# Intel Technical Advisory

TA-1091-01

## Customer will encounter Hyper-V and VMWare installation issues when using BIOS R03.02.0002.

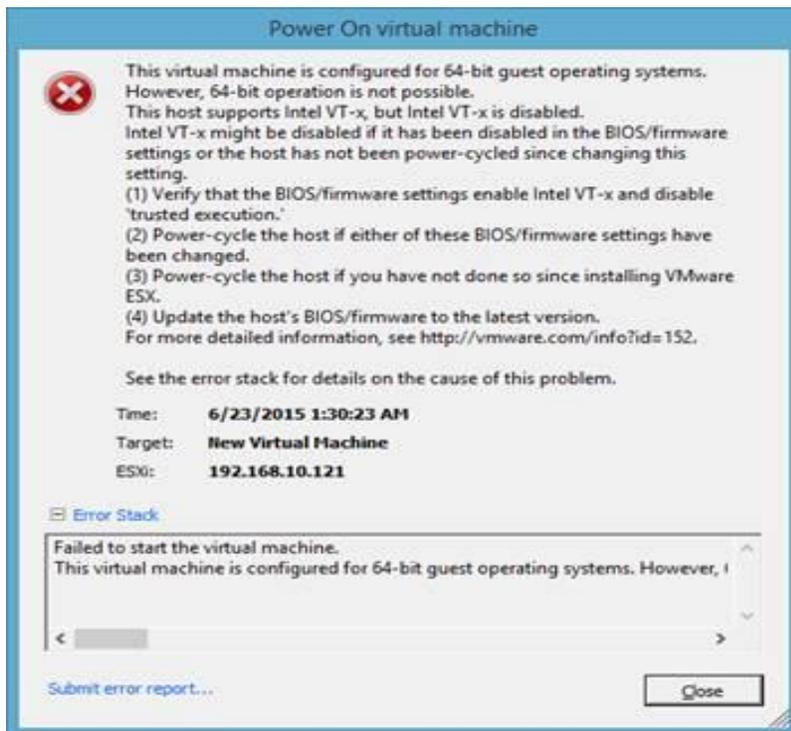
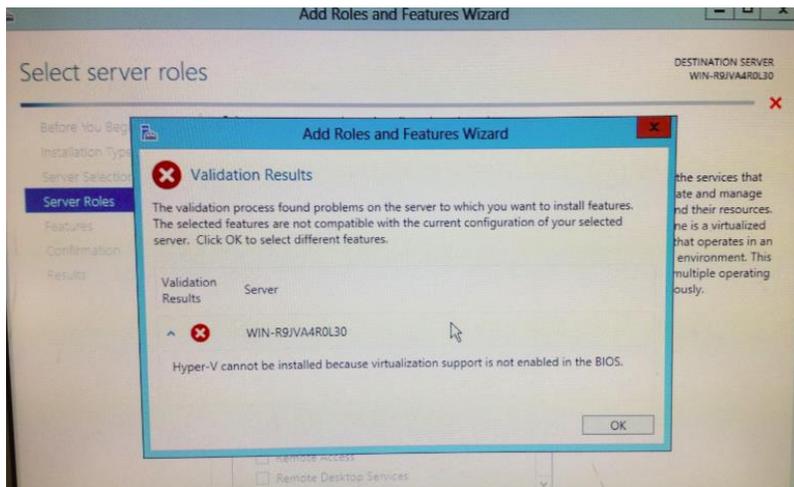
Customers will encounter an issue that they fail to install Hyper-V and VMware after upgrading BIOS to R03.02.0002. Please find the screen shot of the error below:

- Picture 2-1: Vmware

● Picture 2-2: Hyper-V

This BIOS was withdrawn from Intel website. The new BIOS R03.02.0003 has fixed this issue and it is available on website: <https://downloadcenter.intel.com/product/77870/Intel-Server-Board-S1200RP>
